Responses to Question raised from Tender Documents

Title: Construction Works to form two Control Rooms in existing Buildings at The Pirbright Institute

Project: Conversion and Alterations to Building Management System Control Rooms

Date: 3rd May 2023

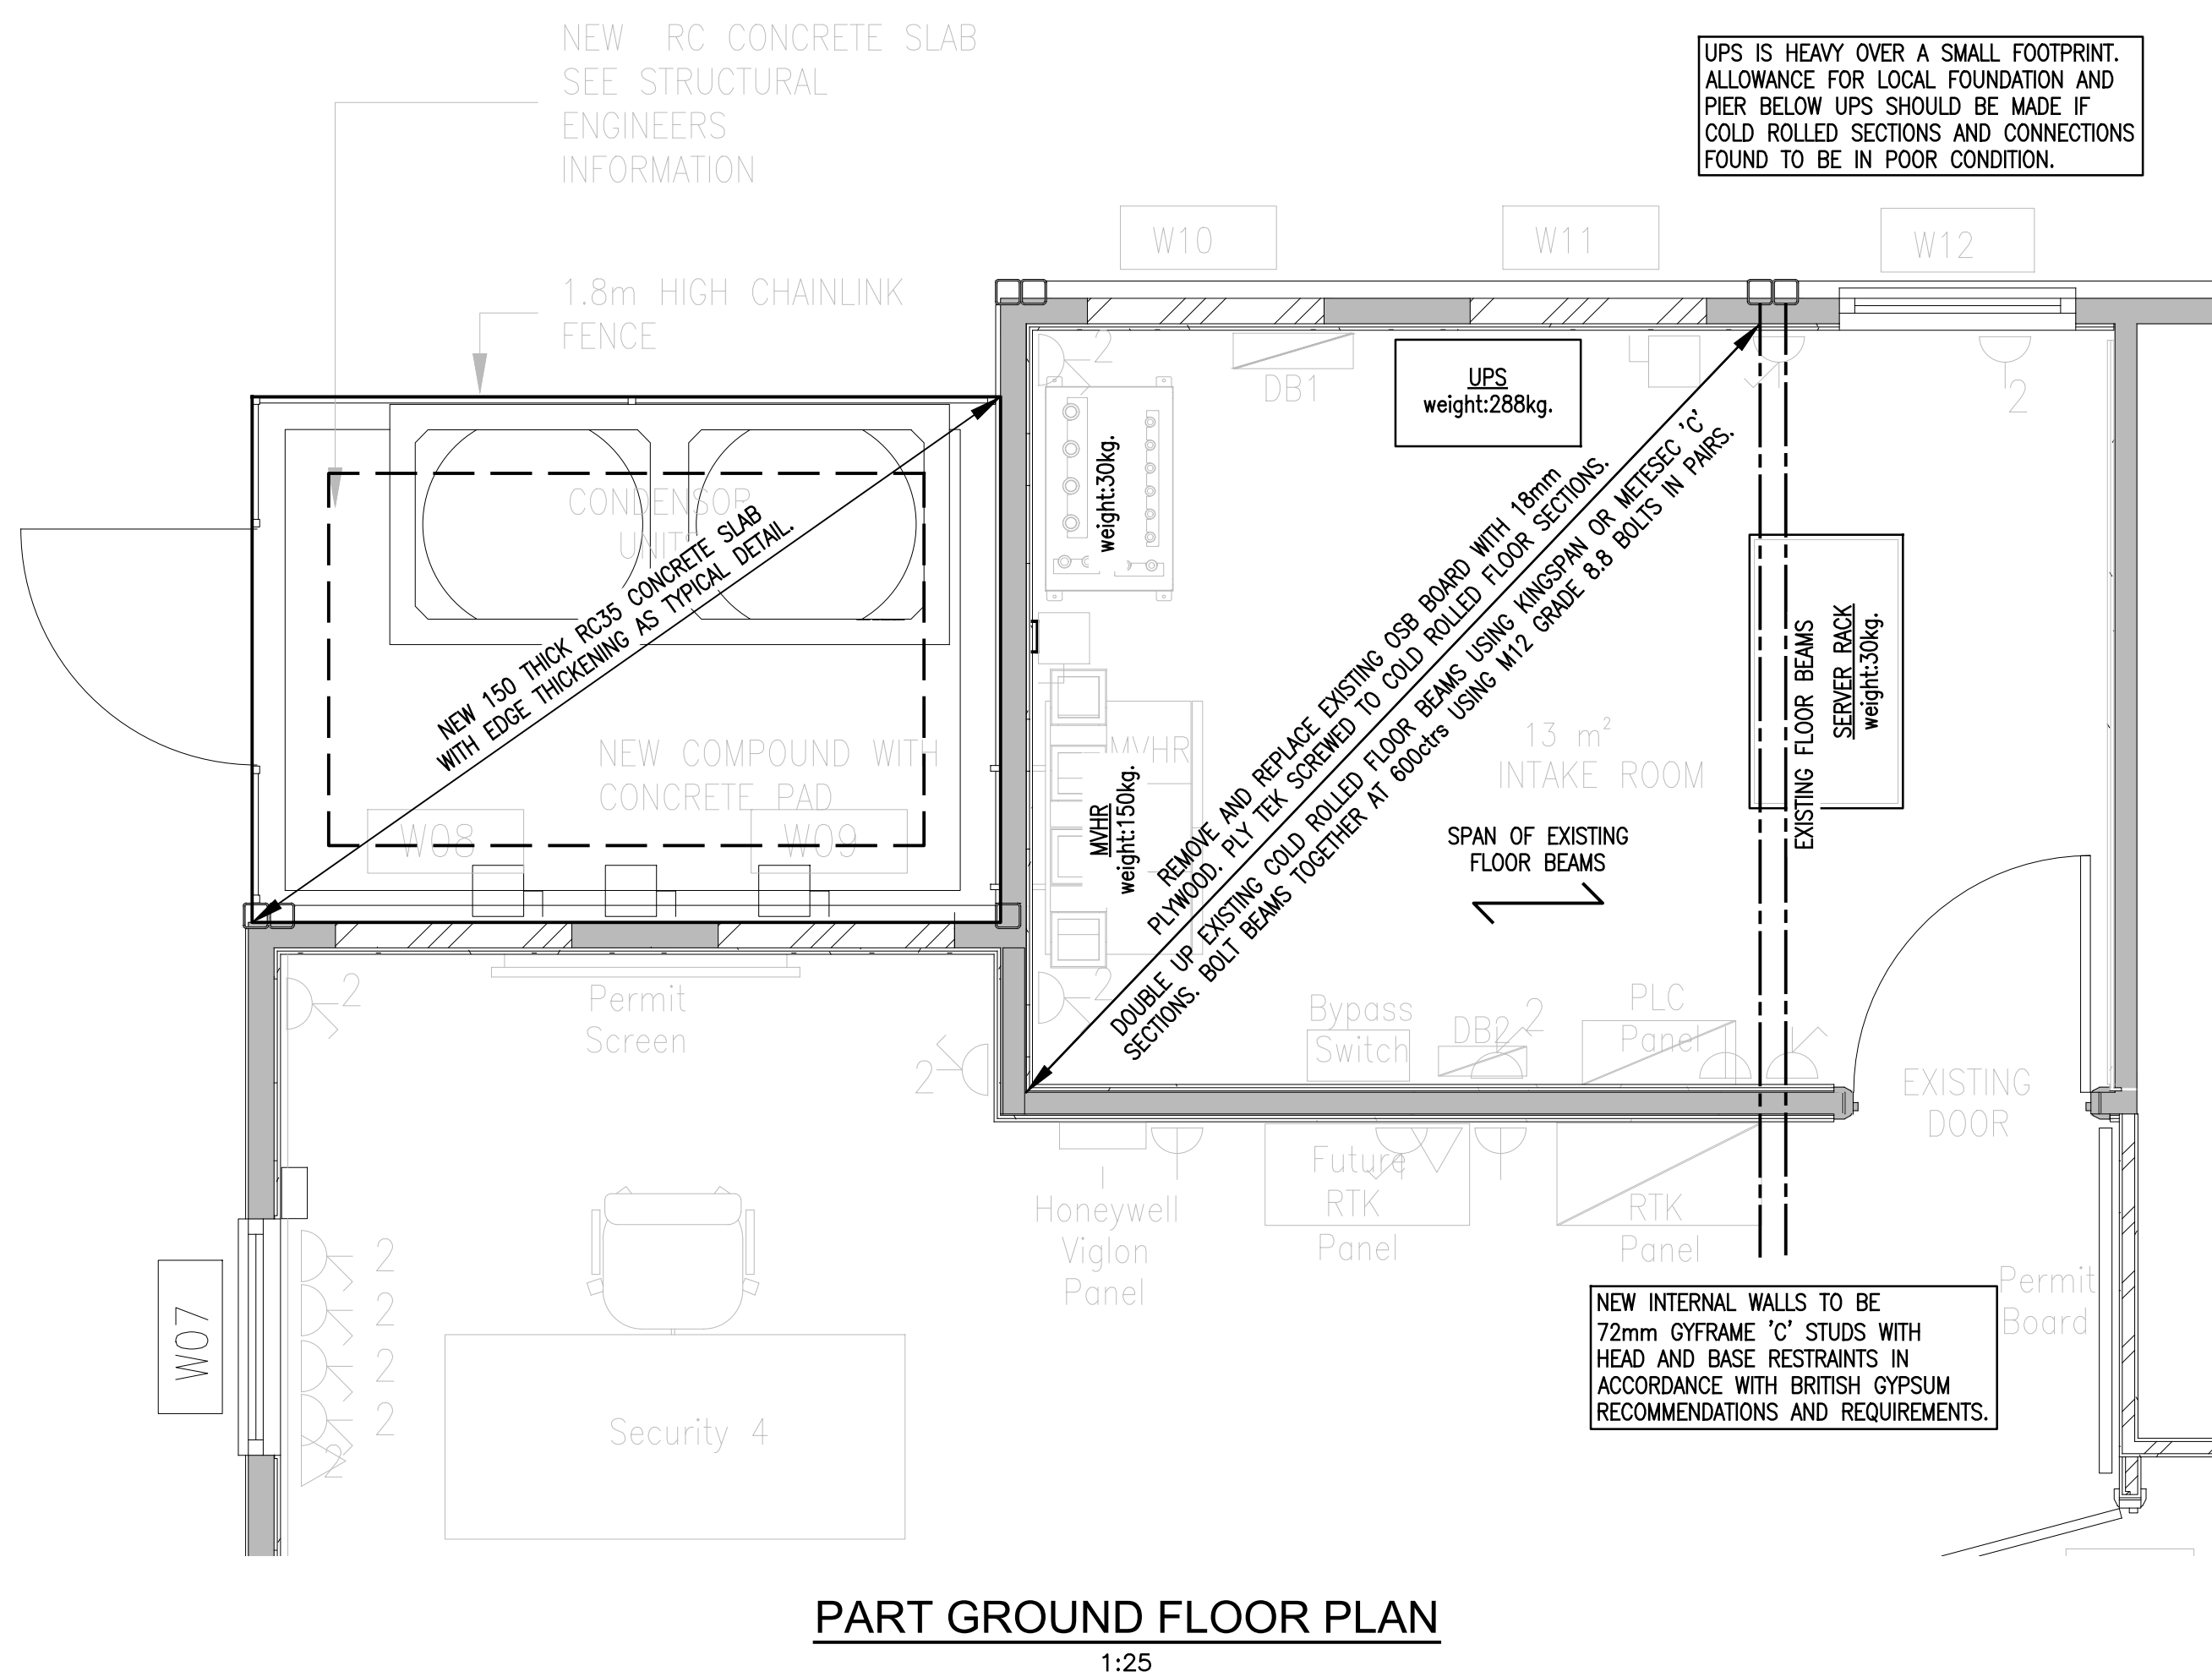
Please see a revised Section 5.7 below making it clear that the Contractor should install the data wiring system.

The Contractor shall supply and install a new IT voice data wiring system in category 6 UTP copper cable installed within dedicated cable basket/tray and conduit containment systems, terminating in RJ45 line jack outlets as indicated on the drawings.

Final data wiring connections to the existing IT rack switches in the Intake room MOD 2 shall be terminated and Dressed by Contractor.

Final data wiring connections to the existing IT rack switches in Plowright shall be terminated and Dressed by Contractor

The Electrical Contractor shall provide and install the new containment for the new IT/Data installation and back boxes in the area scope of this specification. The terminations in both ends of the cable, testing and commissioning shall be carried out by the Contractor as directed by the Client (IT dept. engineers).

The scope of the works shall be as follows but not be limited to:

- Provision of new cable containment systems (Electrical Contractor)
- Provision of new data cabling (Electrical Contractor)
- Provision of new data terminations at outlet points (Electrical Contractor)
- Provision of new RJ45 data outlets (Electrical Contractor)
- Labelling of outlets and cables at both ends. (Electrical Contractor)
- Test and Certification (Electrical Contractor)

The IT data wiring system shall be carried out in category 6 UTP copper cable installed within dedicated Dado, Basket, and conduit containment systems, terminating in RJ45 line jack outlets.

The reminder of Section 5.7 remains as issued.
